MANDATORY SERVICE BULLETIN

IS-28B2/EO-6

Product : IS-28B2 glider.

Object : Fixing the front seat back rod.

APPENDIX I

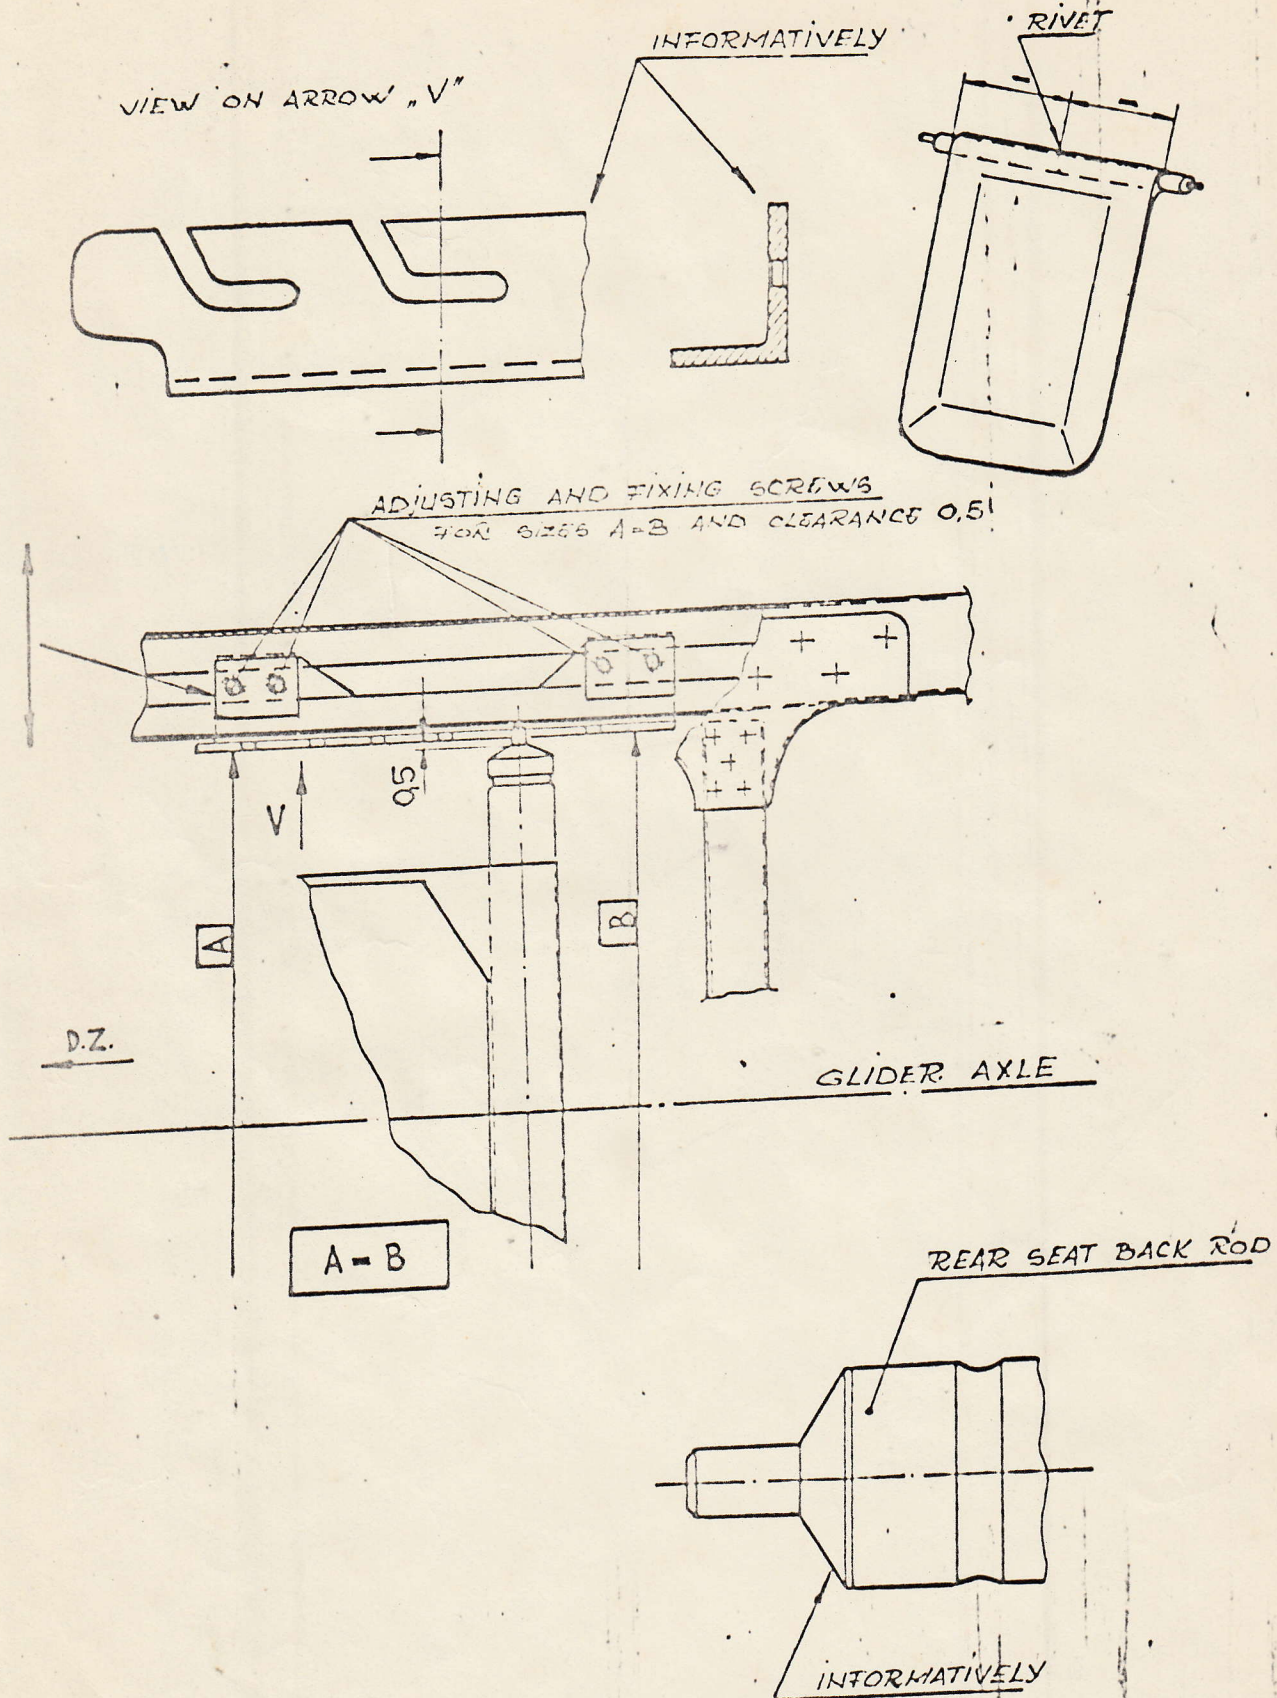
1. Fixing the front seat back with rivet according to Appendix I.
2. Checking and adjusting the front seat back rod clearance according to the indications in Appendix I.
